CLINTON CSO STORAGE FACILITY PROJECT

CONTRACT NO. 7
BID REFERENCE NO. 7234
PROJECT NO. 587960

COUNTY OF ONONDAGA
DEPARTMENT OF WATER ENVIRONMENT PROTECTION
TOM RHOADS, P.E., COMMISSIONER

RECORD DRAWING

6' DIA. CATCH BASIN AT CURB INLET - PLAN
NOT TO SCALE

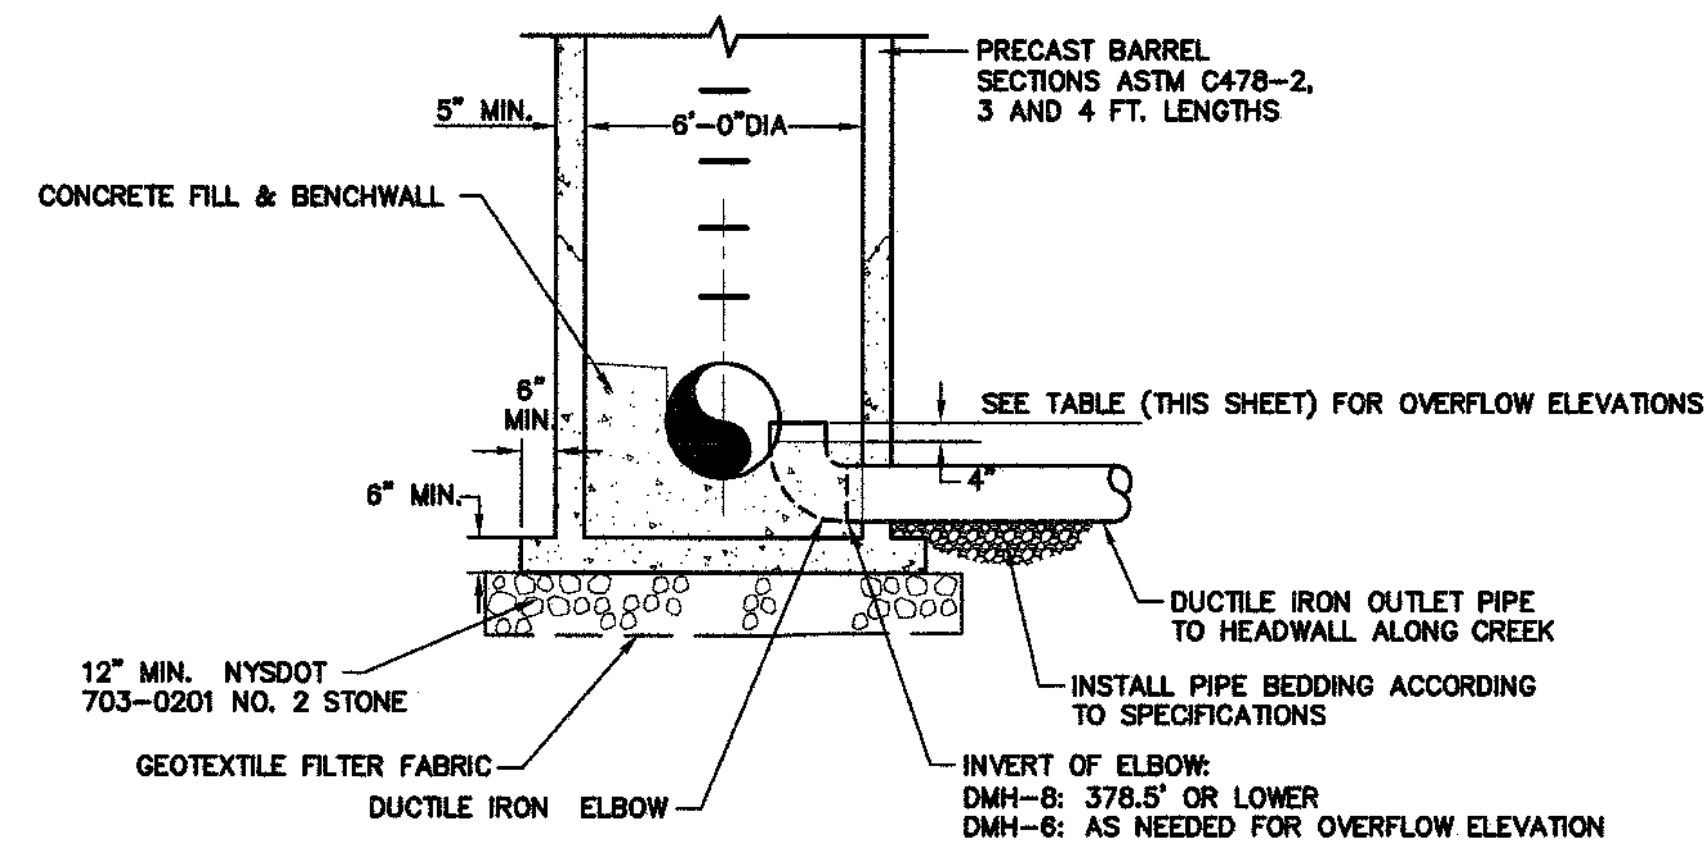
RF1210 IN LIEU OF PROVIDING 2 JOINTS WITHIN 4 FEET OF THE STRUCTURE, IT IS ACCEPTABLE TO PROVIDE 1 JOINT WITHIN 2 FEET OF THE STRUCTURE.

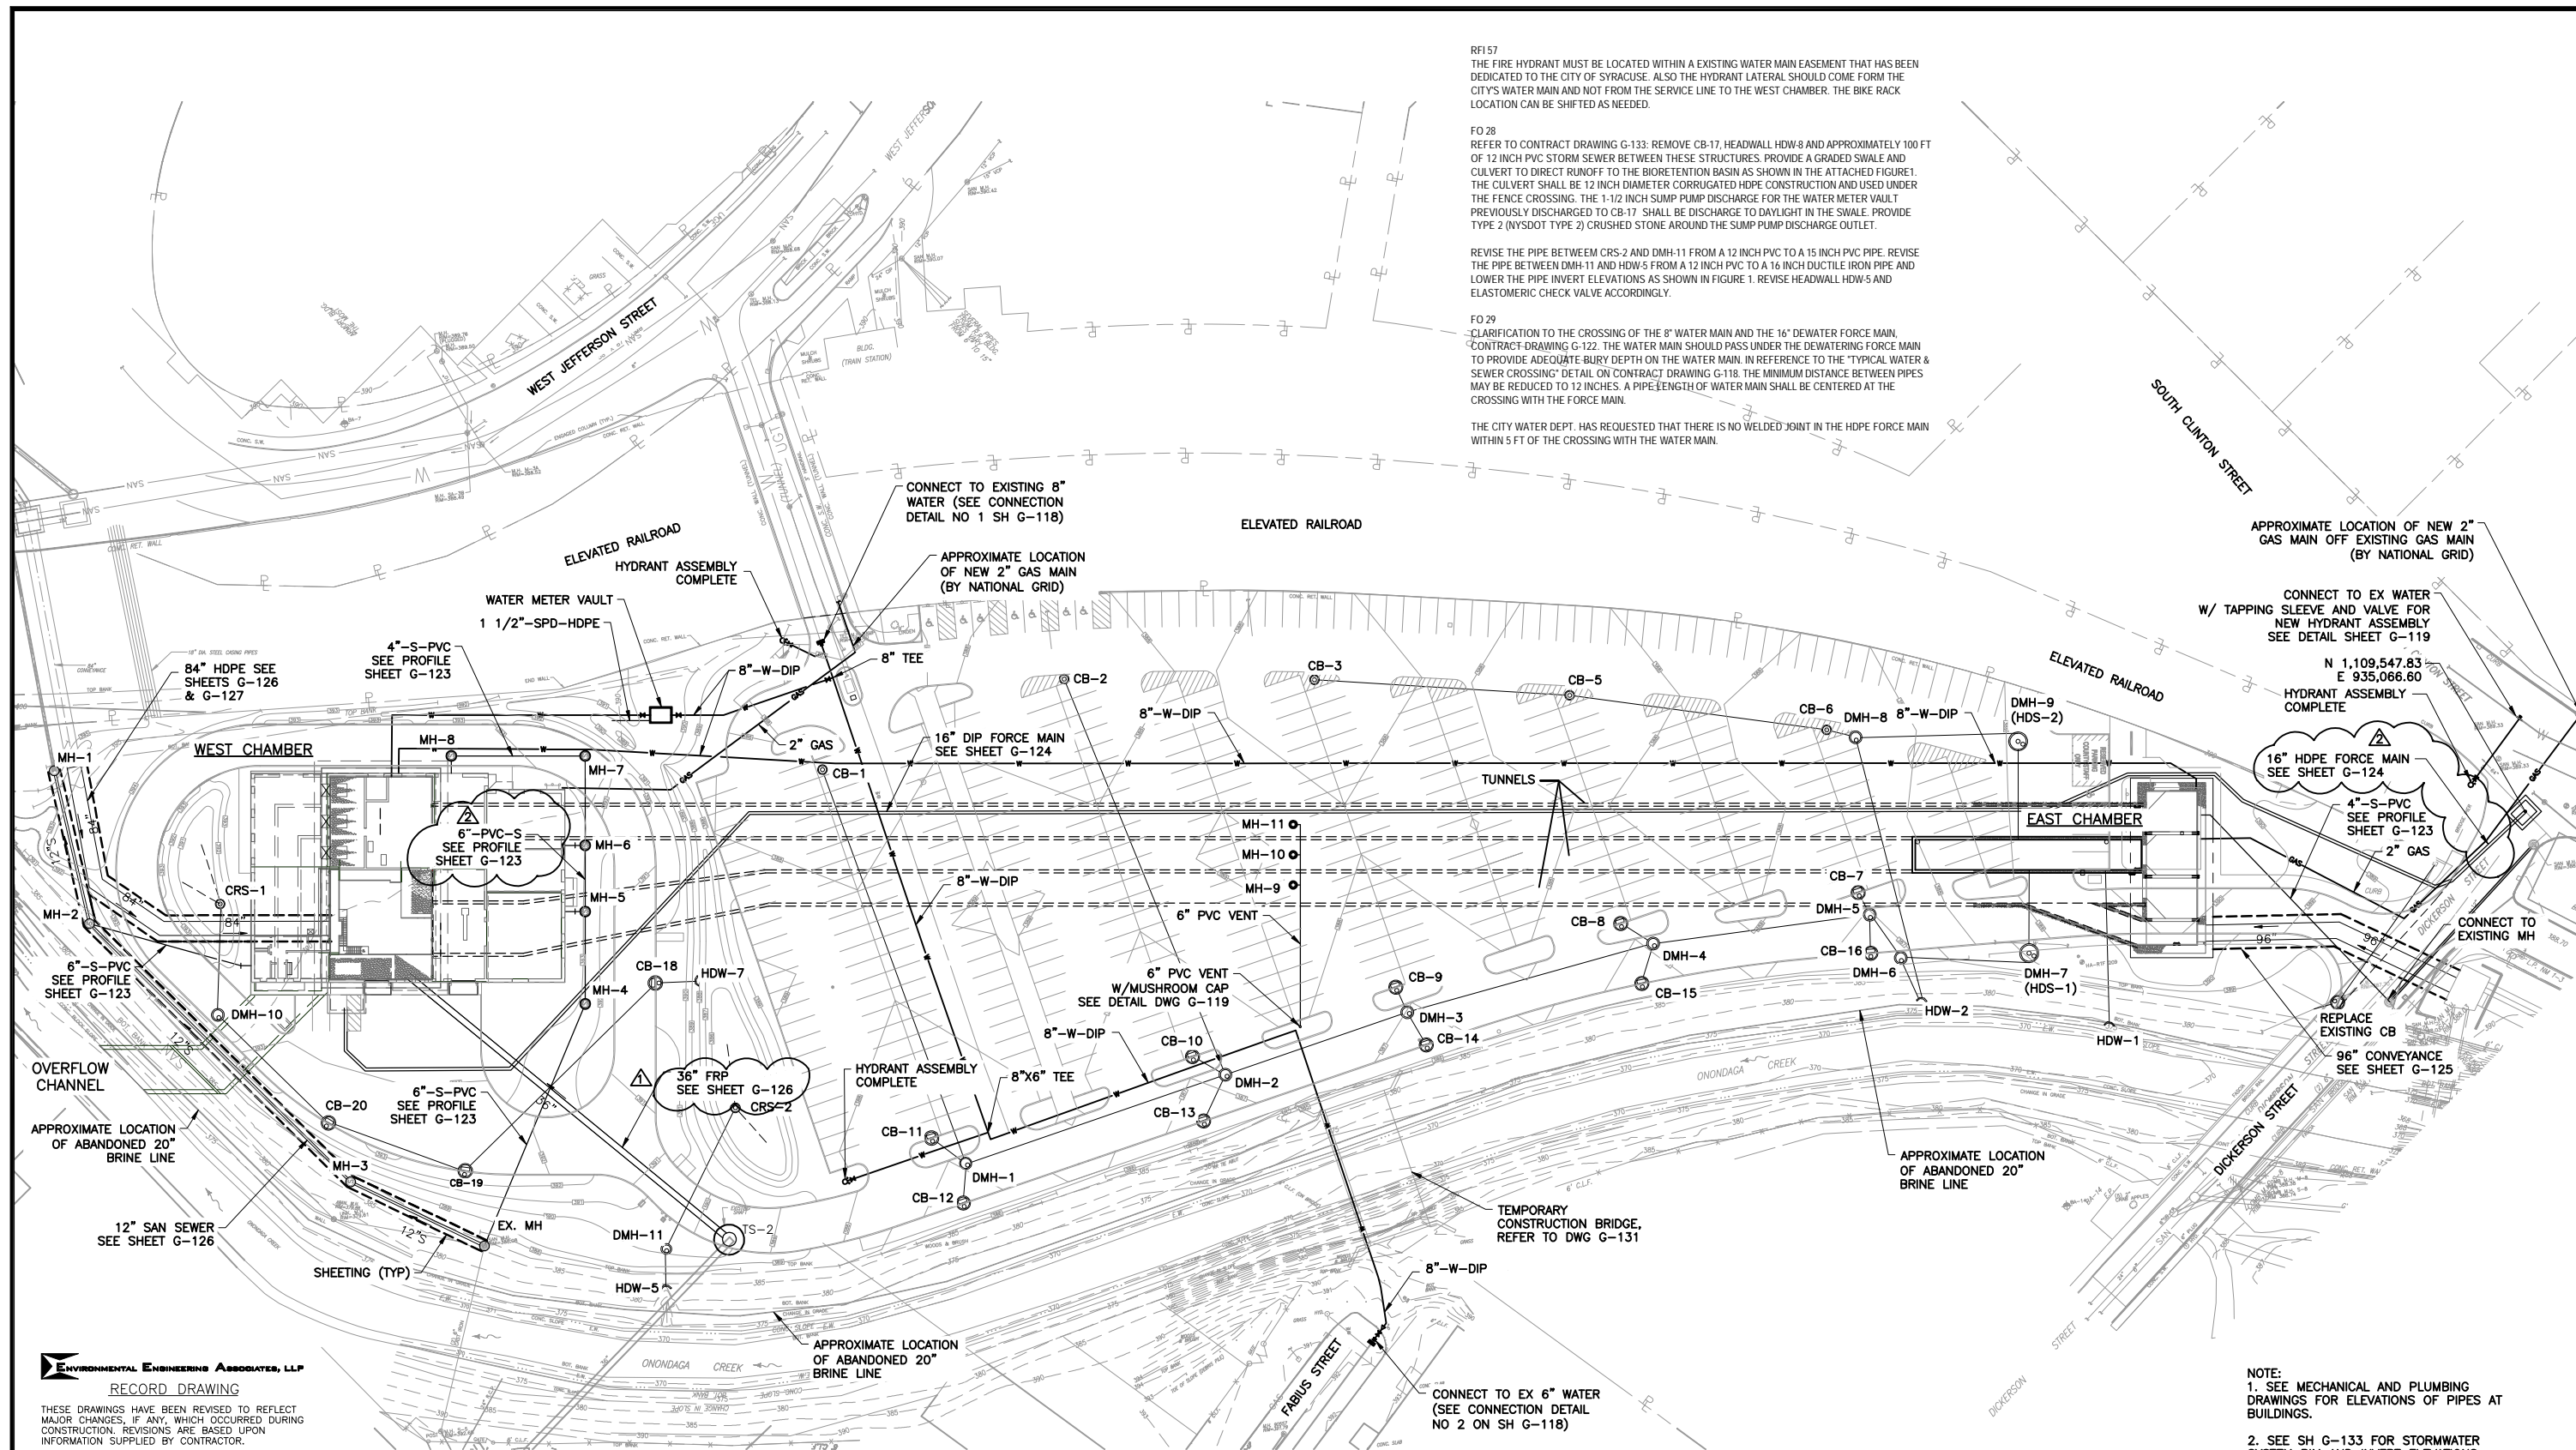
FO 29
CLARIFICATION TO THE CROSSING OF THE 8" WATER MAIN AND THE 16" DEWATER FORCE MAIN. CONTRACT DRAWING G-122. THE WATER MAIN SHOULD PASS UNDER THE DEWATERING FORCE MAIN TO PROVIDE ADEQUATE BURY DEPTH ON THE WATER MAIN. IN REFERENCE TO THE 'TYPICAL WATER & SEWER CROSSING' DETAIL ON CONTRACT DRAWING G-118. THE MINIMUM DISTANCE BETWEEN PIPES MAY BE REDUCED TO 12 INCHES. A PIPE LENGTH OF WATER MAIN SHALL BE CENTERED AT THE CROSSING WITH THE FORCE MAIN.

THE CITY WATER DEPT. HAS REQUESTED THAT THERE IS NO WELDED JOINT IN THE HDPE FORCE MAIN WITHIN 5 FT OF THE CROSSING WITH THE WATER MAIN.

CONNECTION DETAIL FOR 84" PIPE TO WEST CHAMBER

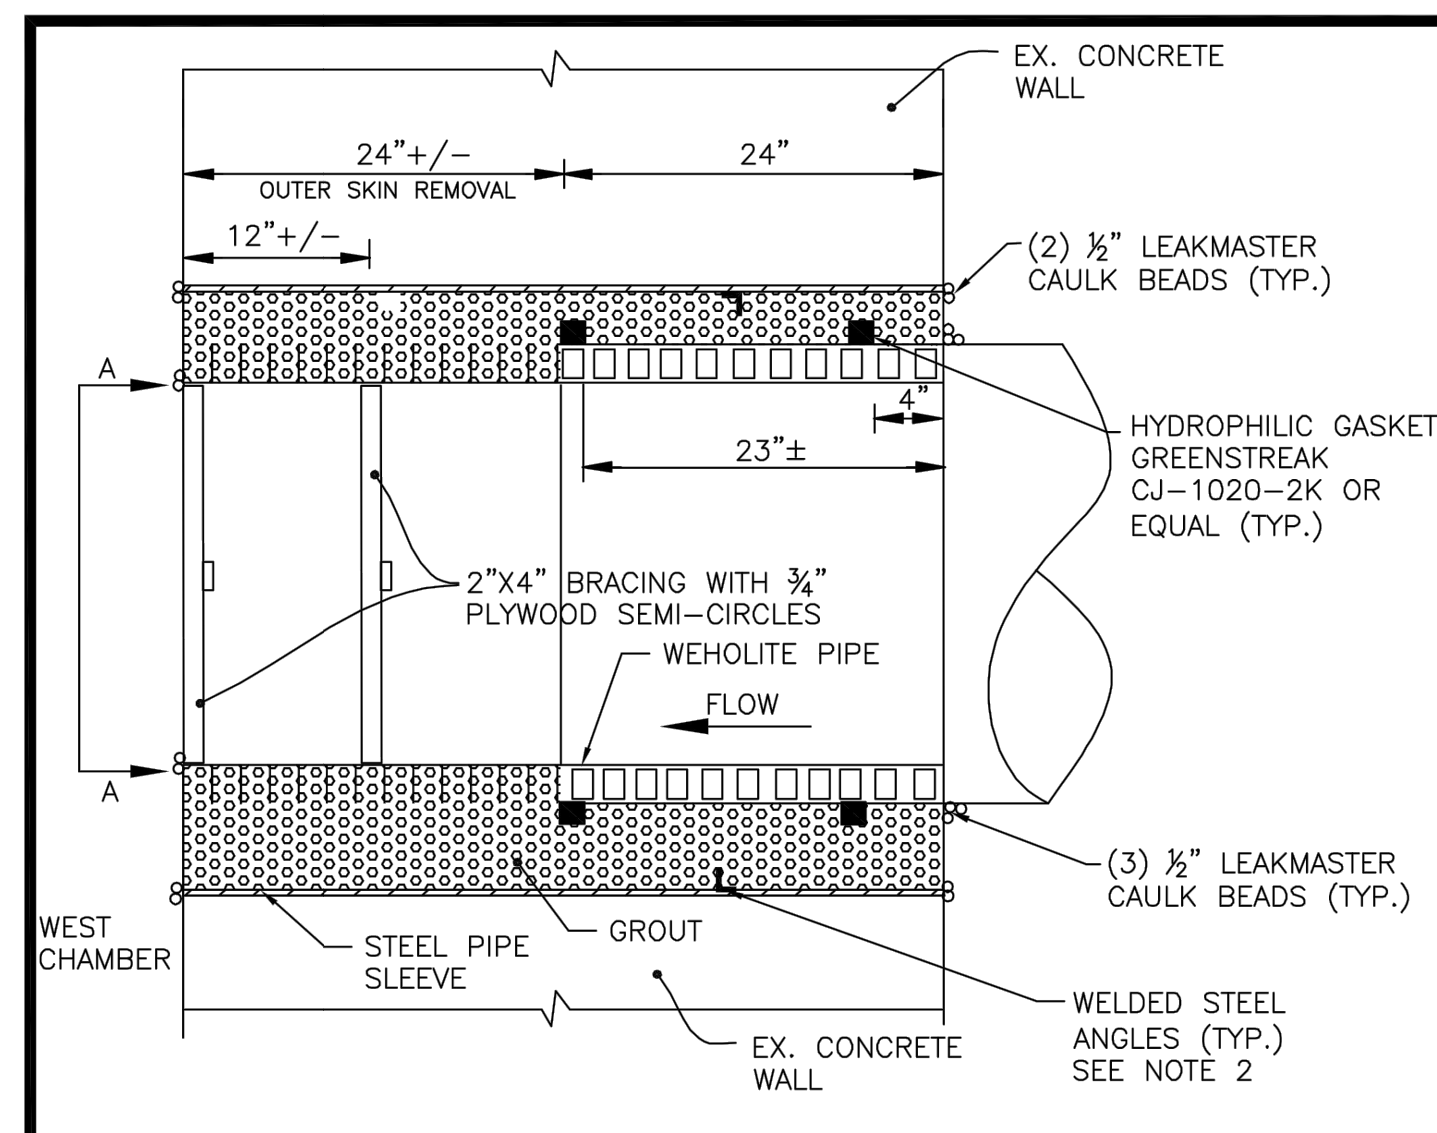
1. REMOVE EXISTING 3/4" STAINLESS STEEL ANCHOR BOLTS.
2. REMOVE AND DISPOSE OF EXISTING W8X24'S.
3. REMOVE AND DISPOSE OF EXISTING REINFORCED CONCRETE KNOCK-OUT.
4. PATCH ALL ANCHOR BOLT HOLES IN STRUCTURAL WALL W/NON-SHRINK GROUT.

File Number 00663
Date 04/11
G-133

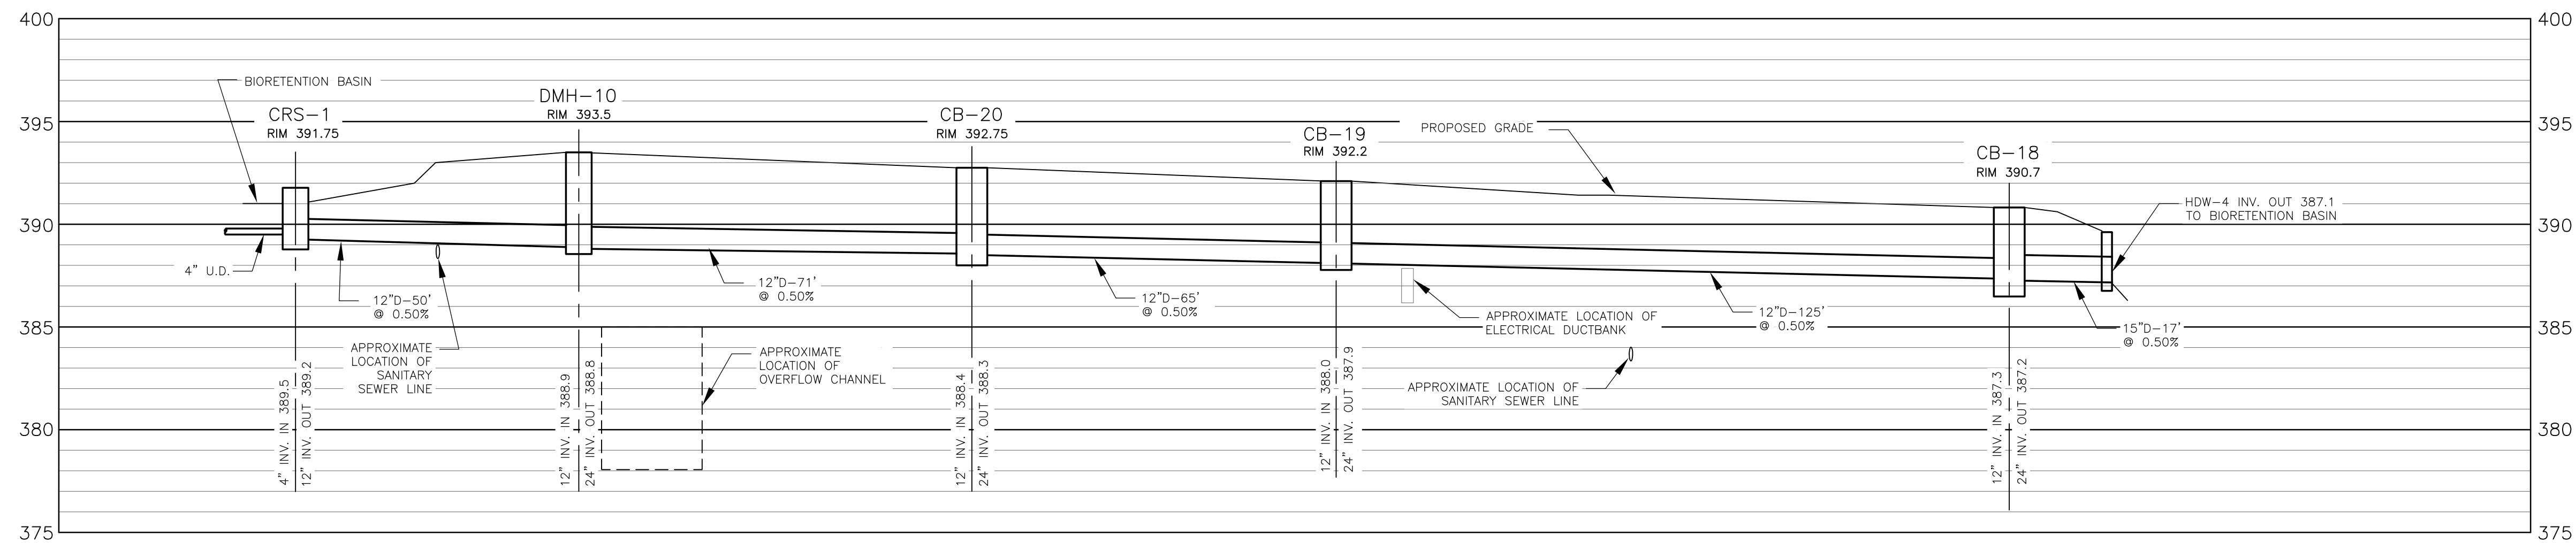
FO 28
REFER TO CONTRACT DRAWING G-133: REMOVE CB-17, HEADWALL HDW-8 AND APPROXIMATELY 100 FT OF 12 INCH PVC STORM SEWER IN BETWEEN THESE STRUCTURES. PROVIDE A GRADED SWALE AND CULVERT TO DIRECT RUNOFF TO THE BIORETENTION BASIN AS SHOWN IN THE ATTACHED FIGURE 1. THE CULVERT SHALL BE 12 INCH DIAMETER CORRUGATED HDPE CORRUGATED CONSTRUCTION AND USED UNDER THE FENCE CROSSING. THE 1-1/2 INCH SUMP PUMP DISCHARGE FOR THE WATER METER VAULT PREVIOUSLY DISCHARGED TO CB-17 SHALL BE DISCHARGED TO DAYLIGHT IN THE SWALE. PROVIDE TYPE 2 (NYS DOT TYPE 2) CRUSHED STONE AROUND THE SUMP PUMP DISCHARGE OUTLET.

REVISE THE PIPE BETWEEN THE CRS-2 AND DMH-11 FROM A 12 INCH PVC TO A 15 INCH PVC PIPE. REVISE THE PIPE BETWEEN DMH-11 AND HDW-5 FROM A 12 INCH DUCTILE IRON PIPE AND LOWER THE PIPE INVERT ELEVATIONS AS SHOWN IN FIGURE 1. REVISE THE HEADWALL HDW-5 AND ELASTOMERIC CHECK VALVE ACCORDINGLY.

FO 42
IN REVIEW OF SHOP DRAWING 2514-10-03 '6 FT DIAMETER PRECAST CONCRETE CATCH BASINS' IT WAS NOTED THAT THE STORM DRAINS WERE SLIGHTLY TOO SHALLOW TO PROPERLY FIT THE CATCH BASIN. THEREFORE REVISE THE INVERT ELEVATIONS AT CATCH BASIN CB-18 AS FOLLOWS:
12" INVERT IN LOWER FROM 387.3 TO 387.0
15" INVERT OUT LOWER FROM 387.2 TO 386.9
REVISE THE 15" INVERT ELEVATION FOR HEADWALL HDW-7 FROM 387.1 TO 386.85
